**Meeting of the Central Valley Flood Protection Board
July 23, 2010**

Staff Report – Encroachment Permit

**A & G Montna Properties, L.P.
Private Boating Facilities, Sutter County**

Consider approval of Draft Permit No. 18546 (Attachment B)

Attachment C-4, Current Proposal, Boating Facilities Site Plan

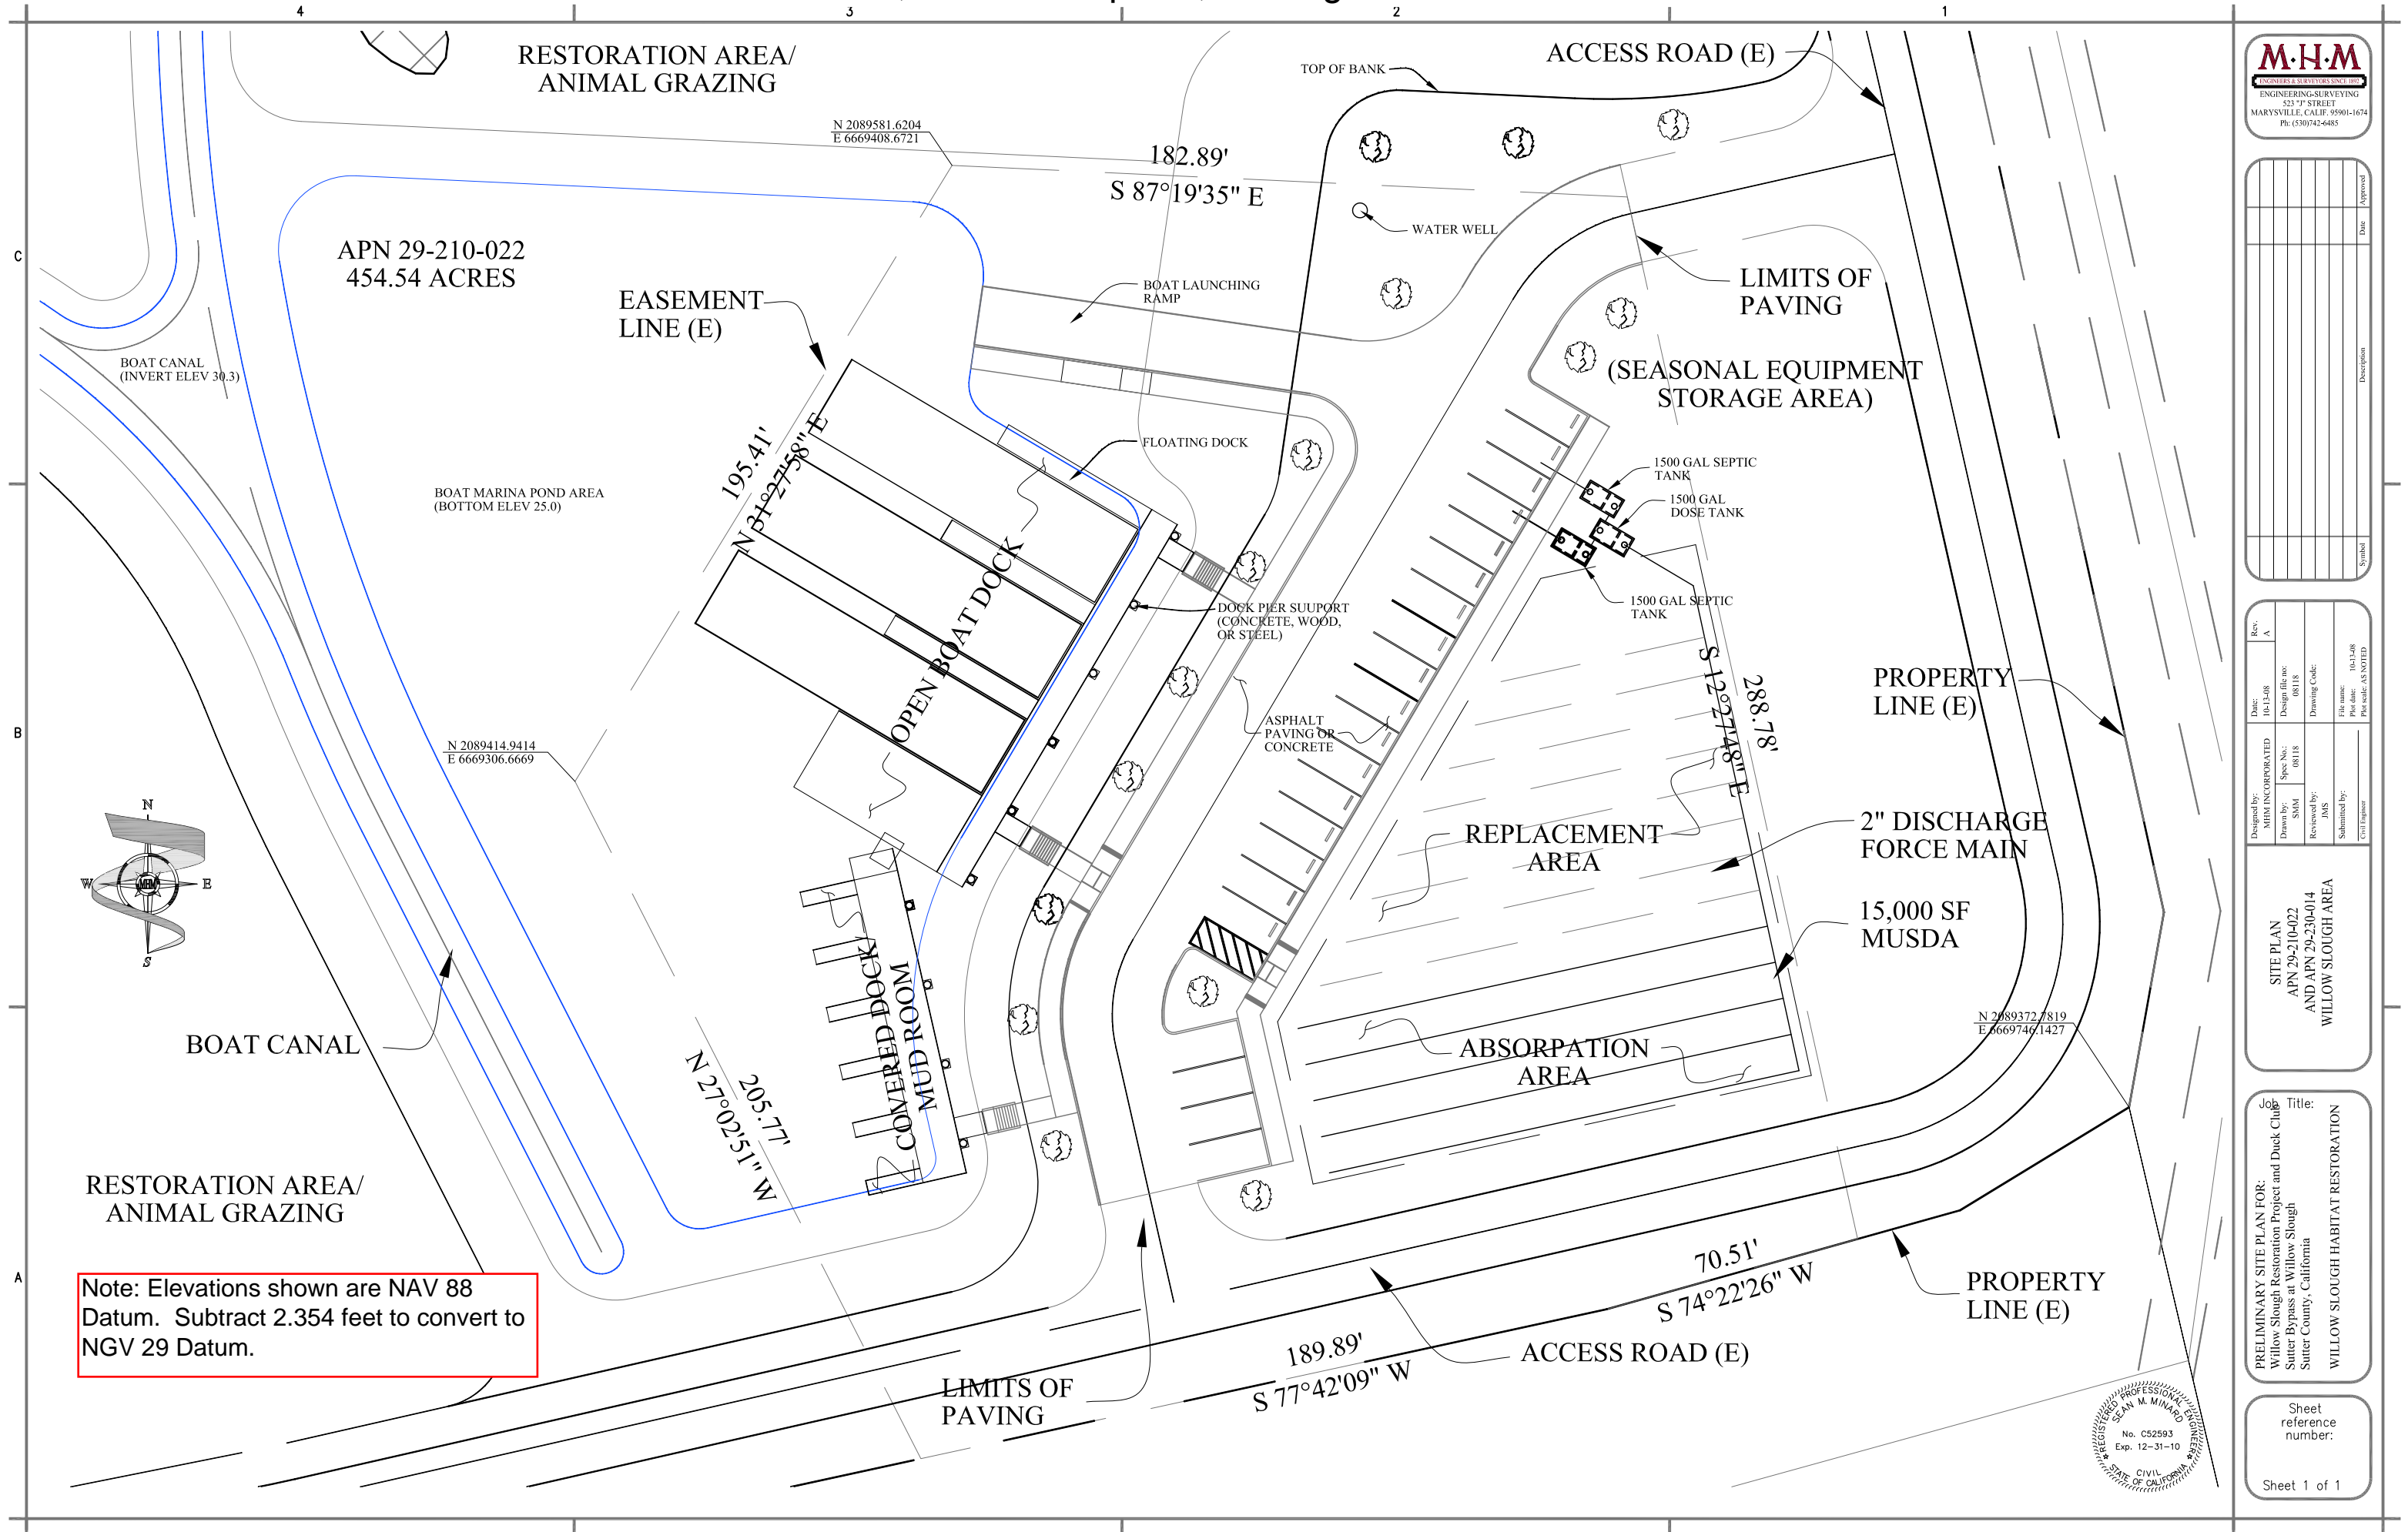
- The project will require an extension of nearby electrical service via overhead lines (see point on Attachment C-3, Proposed Site Map)
- Elevations shown on Attachment C-4, Boating Facilities Site Plan are at NAV 88 datum. The conversion from NAV 88 to NGV 29 datum is - 2.356 feet.
- The bottom of the boat marina pond area is 25.0 NAV 88 (22.64 NGV 29).
- The invert of the boat canal is 30.3 NAV 88 (27.96 NGV 29). Grading for the boat canal was approved in the grading plan under Permit 18439.
- The design WSEL is 32.90 NAV 88 (30.54 NGV 29).
- Propane service will be provided by dock-mounted tank.
- The 14 plants shown on Attachment C-4, Boating Facilities Site Plan will be selected in accordance with Title 23.
- All other design details will be provided in the 100 percent design package.

Attachment C-5, Original Proposal - Clubhouse (Superseded by Boating Facilities)

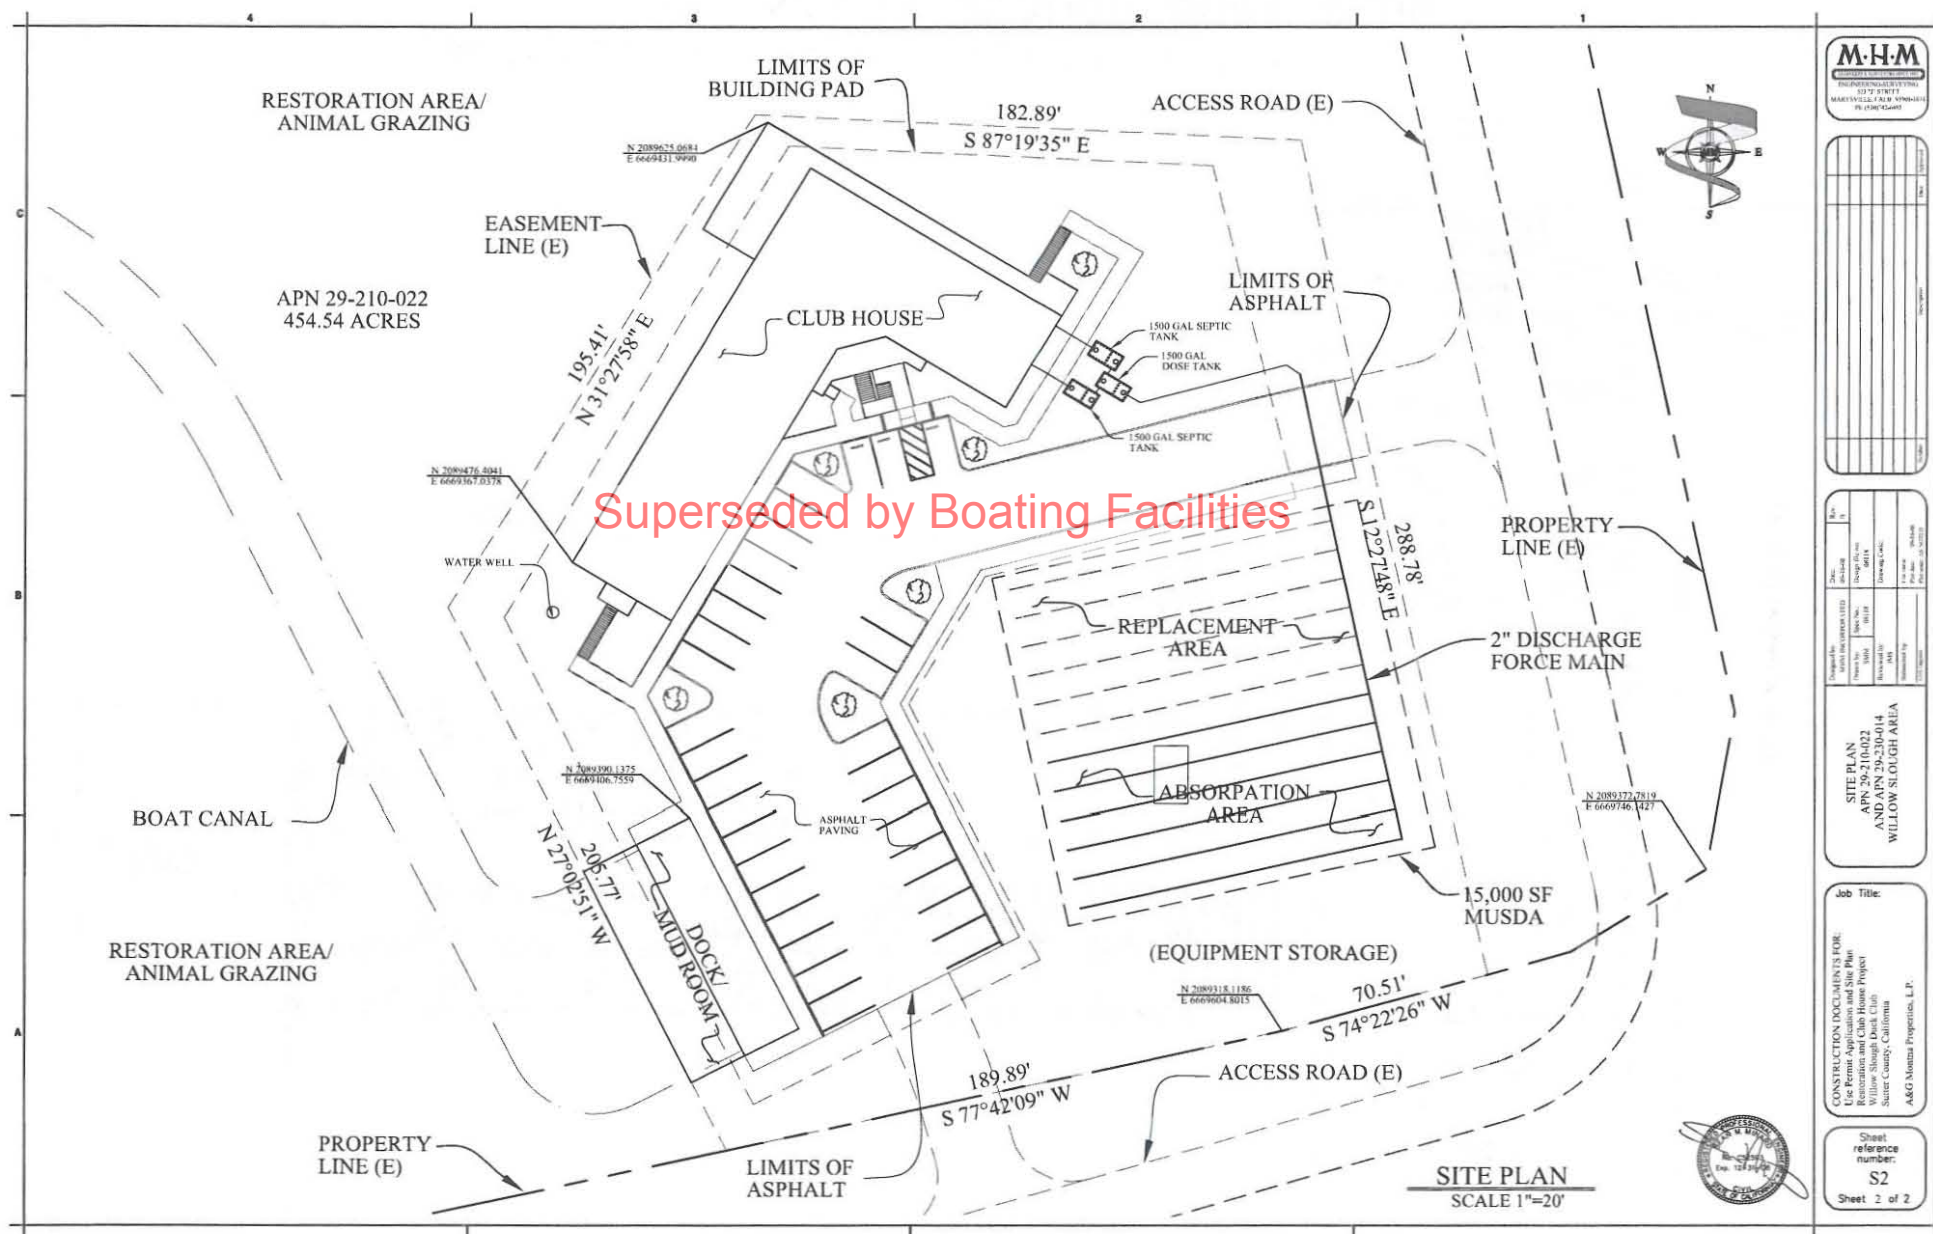
The report evaluated the originally proposed clubhouse. The clubhouse and appurtenances were conservatively simulated by modeling a blocked obstruction 200-feet wide by 100-feet long. The model results determined that the clubhouse would result in no significant hydraulic impacts to the Sacramento River Flood Control Project (Attachment E, highlighted sections on pages 3 – 4).

Since the hydraulic footprint of the boating facilities is not greater than that of the clubhouse Board staff has concluded the boating facilities will also result in no significant hydraulic impacts. For this reason Board staff did not require the applicant to provide a revised analysis specifically for the boating facilities. Staff requested the HEC-RAS data files and forwarded them to the Corps for review.
